**PLAN COMMISSION MEETING AGENDA**  
**Thursday, December 21, 2023 at 6:00 P.M.**

**City of Franklin**  
**Plan Commission Meeting**  
**December 7, 2023**  
**Minutes**

CITY OF FRANKLIN  
REPORT TO THE PLAN COMMISSION

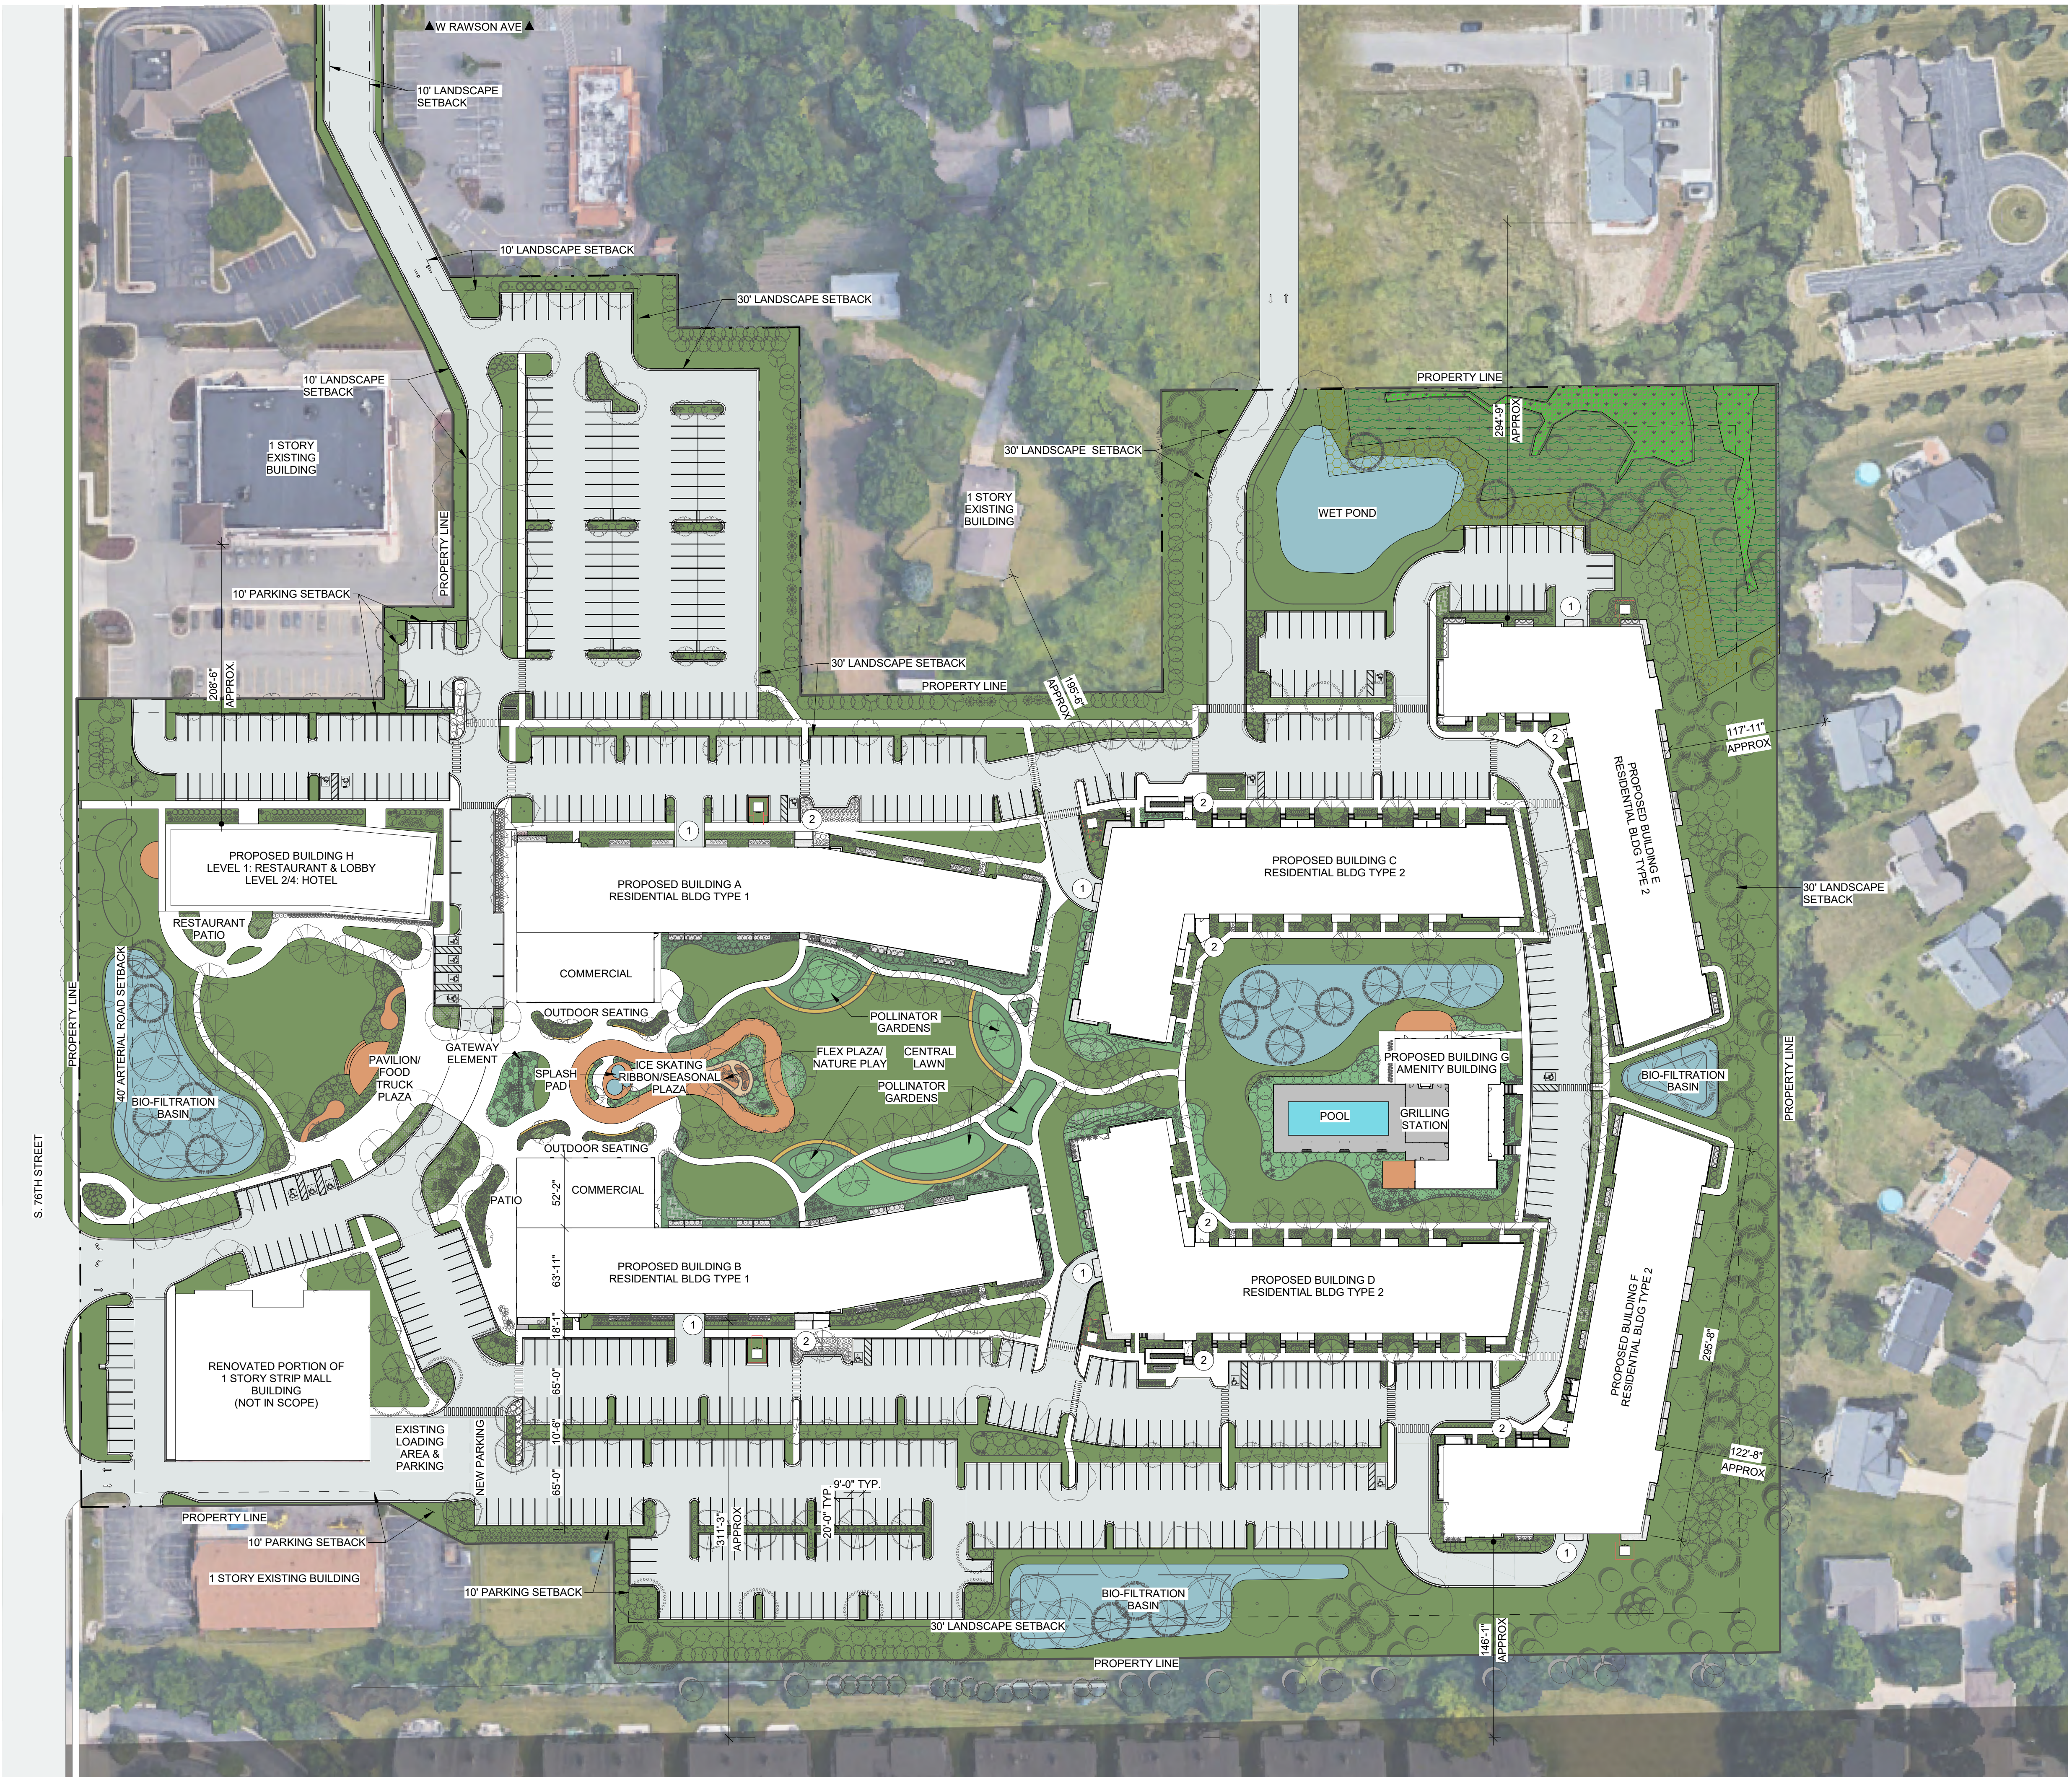
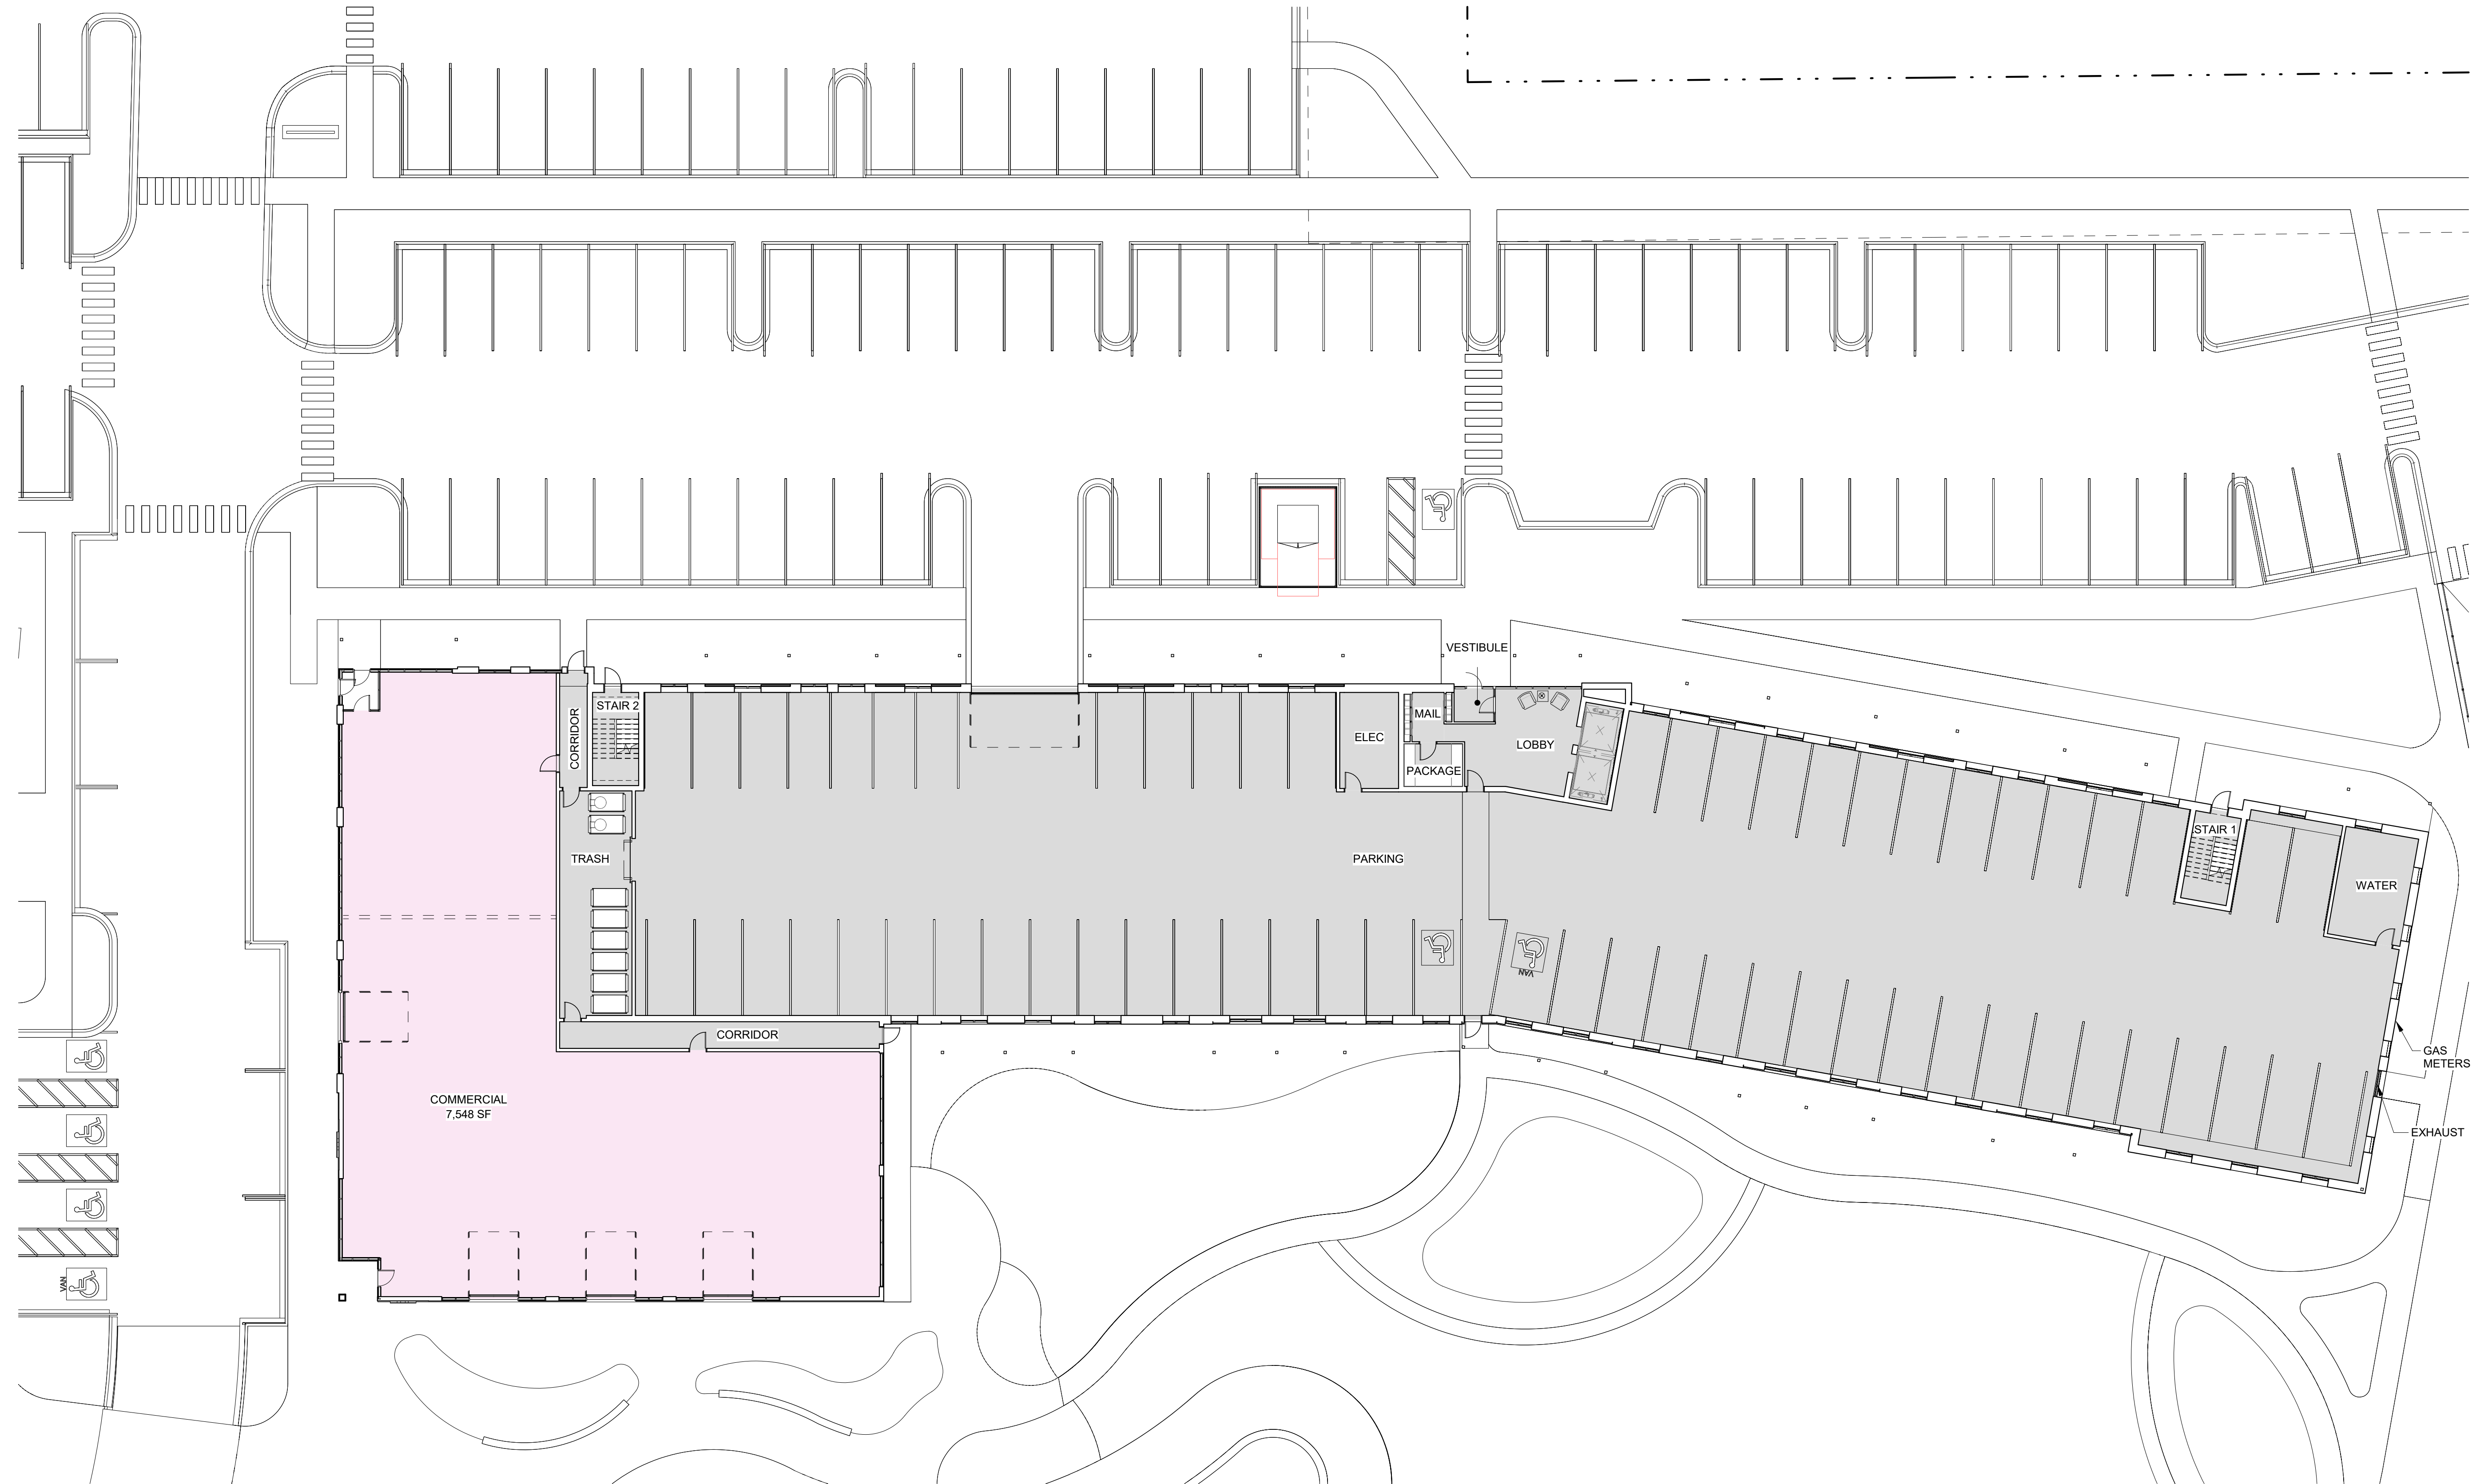
- a. The civil site plans site information table lists 641 total parking spaces. The Architectural Site Plan, Sheet PC-01, includes a total of 694 surface parking spaces. Please confirm the quantity of parking provided.
